Re: 3008832
C&H/156 Cobey

The truss drawing(s) referenced below have been prepared by MiTek USA, Inc. under my direct supervision based on the parameters provided by Builders FirstSource (Valley Center).

Pages or sheets covered by this seal: I51285899 thru I51285900

Job	Truss	Truss Type	Qty	Ply	C&H/156 Cobey	151285899
3008832	C2	HIP	1	1	Job Reference (optional)

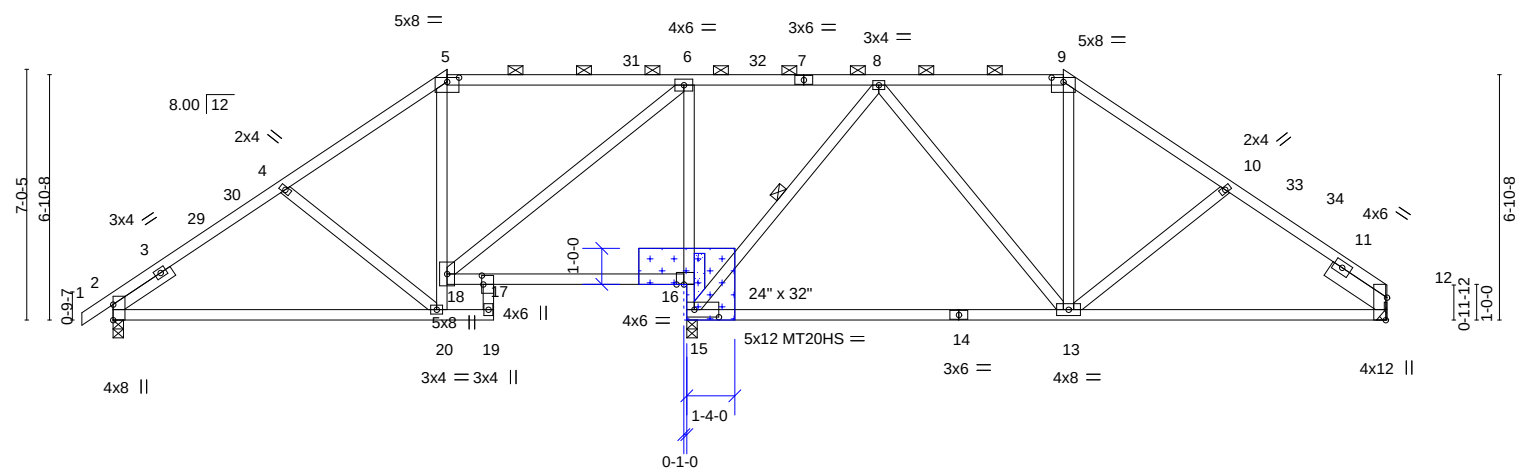
REPAIR: TRIM 0-1-0 FROM MEMBER 15-16

LUMBER AND CONNECTOR PLATES MUST BE CUT CLEANLY AND ACCURATELY
AND THE REMAINING PLATE MUST BE FULLY EMBEDDED AND UNDISTURBED.

ATTACH 1/2" PLYWOOD OR OSB GUSSET (15/32" RATED SHEATHING 32/16 EXP 1)
TO EACH FACE OF TRUSS WITH (0.131" X 2.5" MIN.) NAILS PER THE FOLLOWING NAIL SCHEDULE:
2 X 3'S - 2 ROWS, 2 X 4'S - 3 ROWS, 2 X 6'S AND LARGER - 4 ROWS: SPACED @ 4" O.C.
NAILS TO BE DRIVEN FROM BOTH FACES. STAGGER SPACING FROM FRONT TO BACK FACE
FOR A NET 2" O.C. SPACING IN EACH COVERED TRUSS MEMBER. USE 2" MEMBER END DISTANCE.

INSTALL 2 X 4 X 16" SPF/DF/SP NO.2
CUT TO FIT TIGHT.

Job	Truss	Truss Type	Qty	Ply	C&H/156 Cobey	IS1285900
3008832	C3	ROOF SPECIAL	1	1

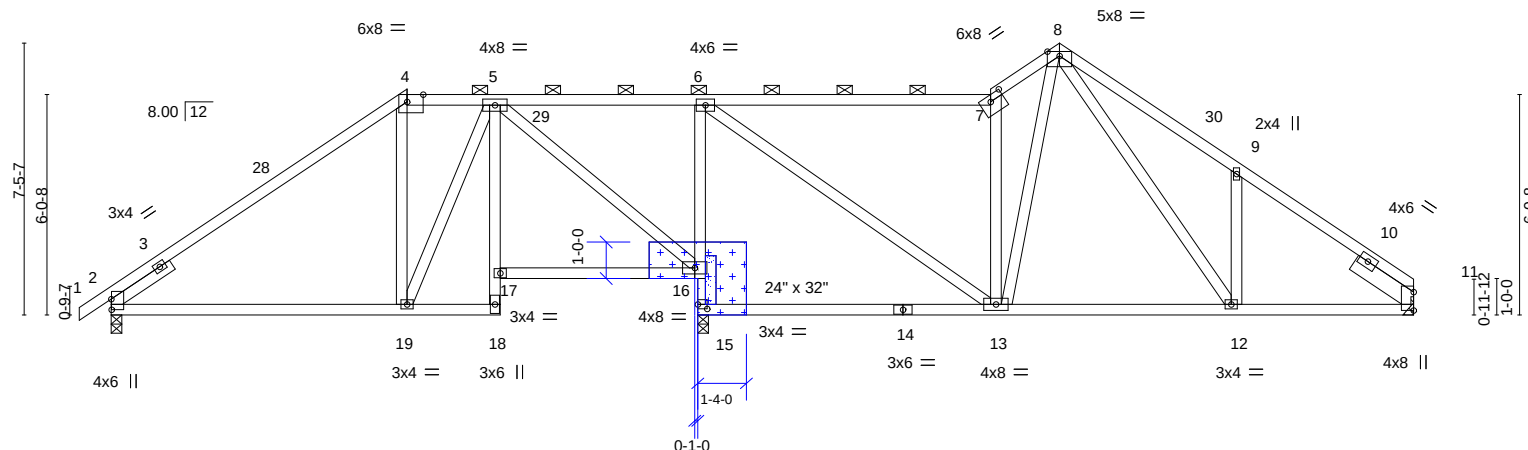
REPAIR: TRIM 0-1-0 FROM MEMBER 15-16

LUMBER AND CONNECTOR PLATES MUST BE CUT CLEANLY AND ACCURATELY AND THE REMAINING PLATE MUST BE FULLY EMBEDDED AND UNDISTURBED.

ATTACH 1/2" PLYWOOD OR OSB GUSSET (15/32" RATED SHEATHING 32/16 EXP 1) TO EACH FACE OF TRUSS WITH (0.131" X 2.5" MIN.) NAILS PER THE FOLLOWING NAIL SCHEDULE: 2 X 3'S - 2 ROWS, 2 X 4'S - 3 ROWS, 2 X 6'S AND LARGER - 4 ROWS: SPACED @ 4" O.C. NAILS TO BE DRIVEN FROM BOTH FACES. STAGGER SPACING FROM FRONT TO BACK FACE FOR A NET 2" O.C. SPACING IN EACH COVERED TRUSS MEMBER. USE 2" MEMBER END DISTANCE.

INSTALL 2 X 4 X 16" SPF/DF/SP NO.2 CUT TO FIT TIGHT.
